Technical Journal

Seat hard to push back, second row seat (7 seater)

REF NO: TJ 32025.4.0	ISSUING DEPARTMENT: Technical Service	CAR MARKET: United States and Canada	
PARTNER: 3 US 7510 Volvo Car USA		ISSUE DATE: 2017-09-26	STATUS DATE: 2017-09-27
FUNC GROUP: 8531	FUNC DESC: Rear seat, complete	Page 1 of 6

2:nd row in 7-seater: Hard to fold back backrest

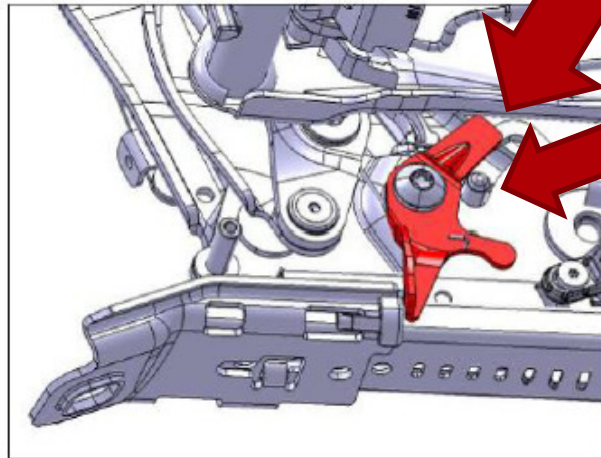
- Outer seat in 2:nd row is hard to move back after entrance to 3:rd row.
- Backrest folds back too early (before seat is slided back).

Stopping edge of rebound bracket wear against the stop screw. This wear prevents it from releasing.

- Replace the rebound bracket.

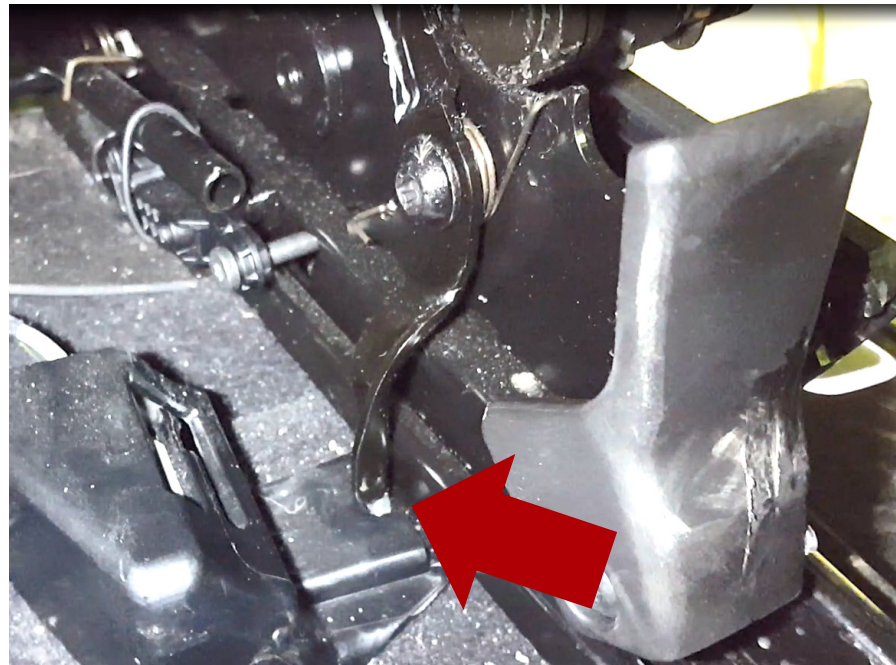
Outer seat in 2:nd row is hard to move back after entrance to 3:rd row.

Lower part of rebound bracket sticks on screw head.

- Grind down the screw head.
- New concept with lower screw head.

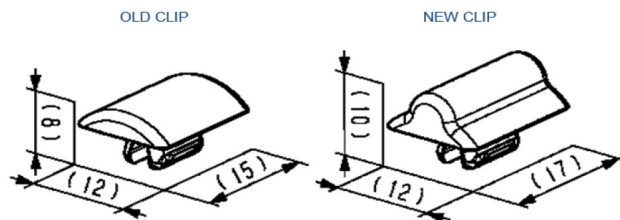
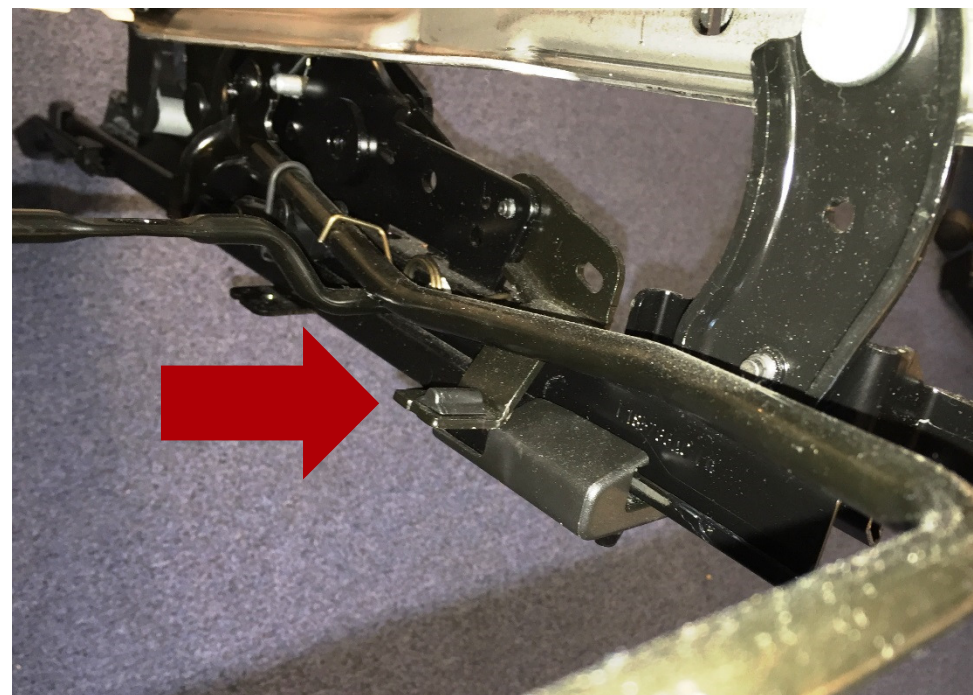
Outer seat in 2:nd row is hard to move or makes rattling noise over the rails.

Plastic stoppers for adjustment lever forward/backward too low.

Replace stoppers to new, higher model.
No p/n change.

Issue: 2:nd Row outer seat, 7 seater

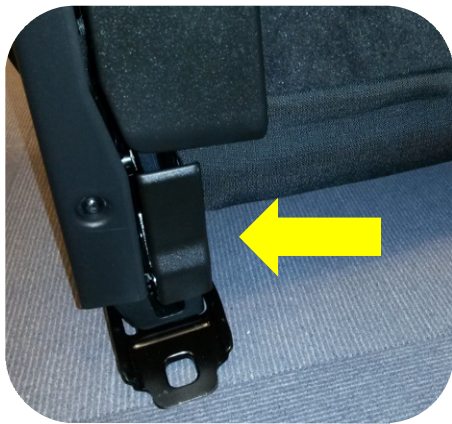
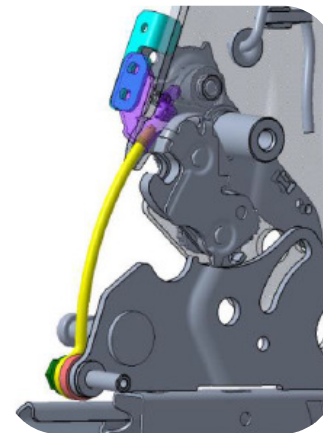
Gap closer can get stuck and damaged when back rest is folded back.
To avoid on current cars: Always start from normal position when seat are supposed to be flat folded. (Do not start from easy entry position.)

Solution step 1 Current Gap closer will be redesigned.

Solution step 2 New concept under development.
